No. EL/11.5.5/1

MODIFICATION SHEET NO.RDSO/2008/EL/MS/0371(REV.0),
DATED 20.01.09

Provision of change over switch in Traction Converter for speed sensor of Traction Motor.

**LOCATION OF SPEED SENSOR CHANGE OVER SWITCH IN LOCO
NO.31173/LGD.**

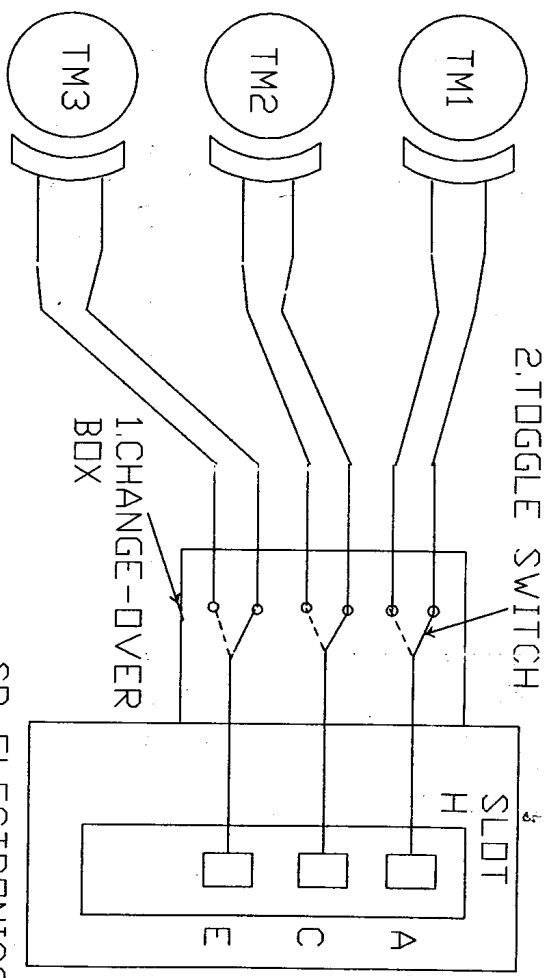
The speed sensor cables are to be connected to ASC peripheral card through changeover switches as per drawing no. SKEL-4755 ALT'0'. These switches are housed in a box mounted on top of the Traction Converter rake.

- i. Attached drawing no. SKEL-4755 ALT'0'.
- ii. Photograph showing location of changeover switch box.
